**PROPOSED AMENDMENT TO NATIONAL POLLUTANT DISCHARGE ELIMINATION SYSTEM PERMIT CA0102695, BOARD ORDER NUMBER R6T-2008-0022, FOR THE SUSANVILLE SANITARY DISTRICT WASTEWATER TREATMENT PLANT, LASSEN COUNTY (WDID: 6A181554001)**

**ORDER NO. R6T-2008-0022-A01(PROPOSED)  
NPDES NO. CA0102695  
WDID 6A181554001**

**AMENDMENT TO WASTE DISCHARGE REQUIREMENTS FOR THE  
SUSANVILLE SANITARY DISTRICT, WASTEWATER TREATMENT PLANT  
DISCHARGES TO THE JENSEN SLOUGH VIA OUTFALL 001, LASSEN COUNTY**

**ATTACHMENT B - MAP**

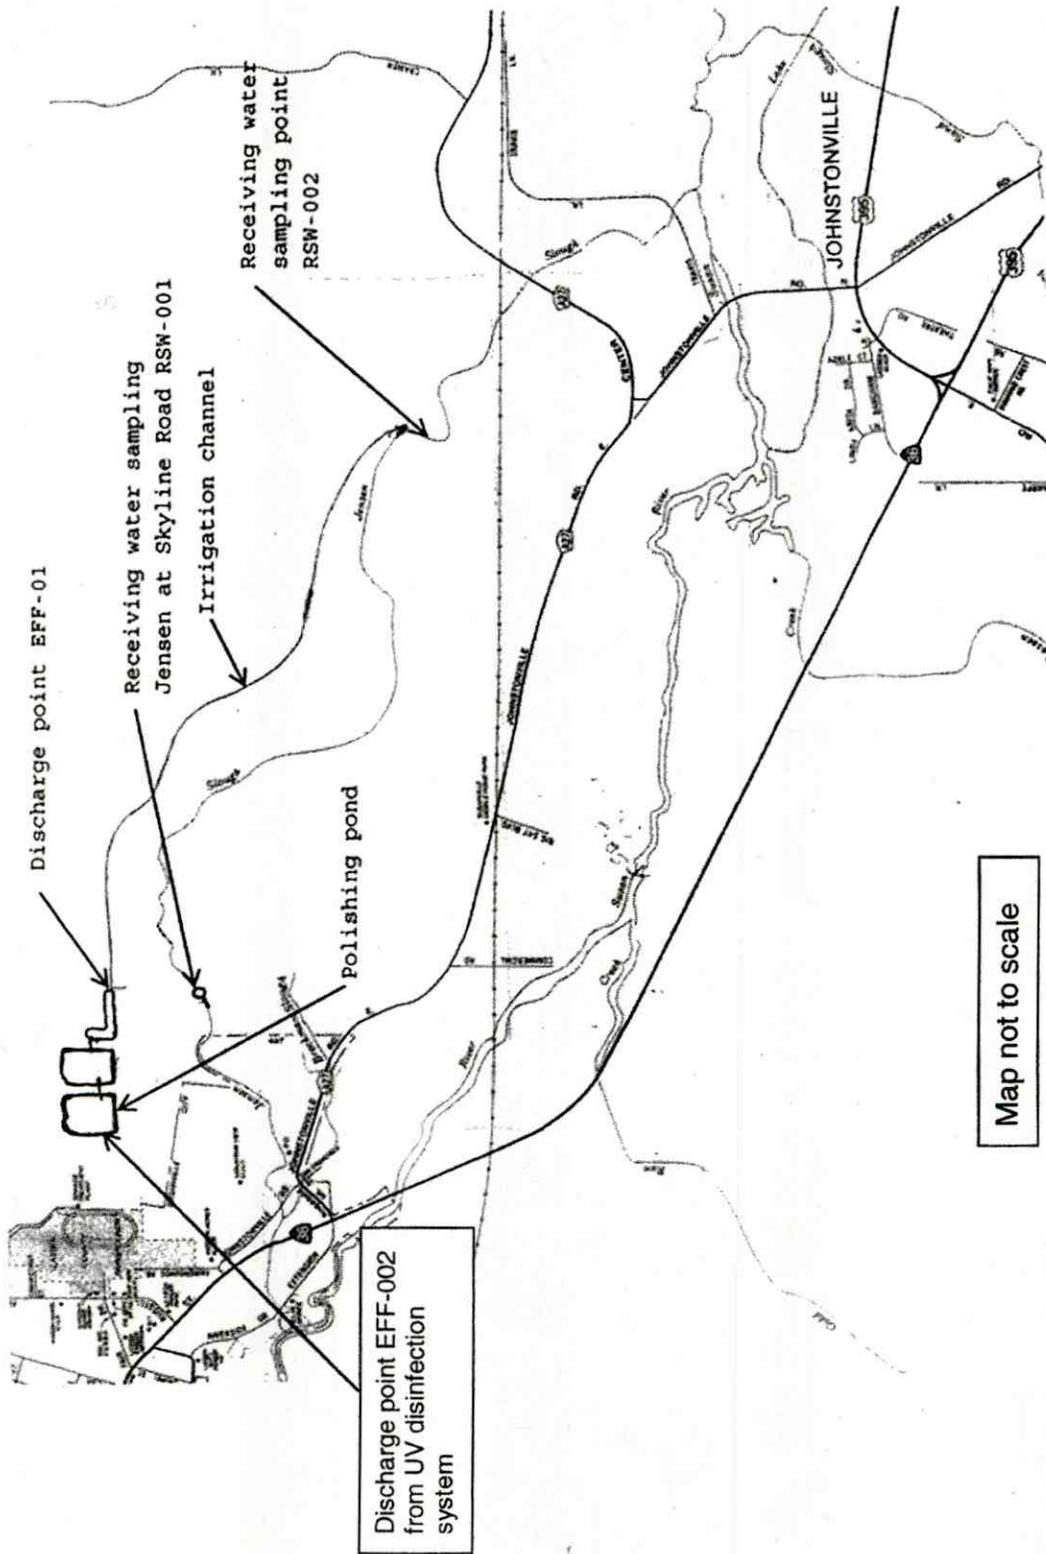
- 4) Change to Attachment B, page B-1 of Order No. R6T-2008-0022: the new page will read as identified in Attachment B to this Order that now identifies the revised Discharge Point EFF-002 from the UV disinfection system, as described in 6), below.
- 5) Change to Attachment C2, page C-2 of Order No. R6T-2008-0022: the new page will read as identified in Attachment C2 to this Order that now identifies the revised Discharge Point EFF-002 from the UV disinfection system, renames the former Discharge Point EFF-002 as Discharge Point EFF-002-CL for when the chlorine system is in use, and identifies discharge point EFF-001 (with no change).
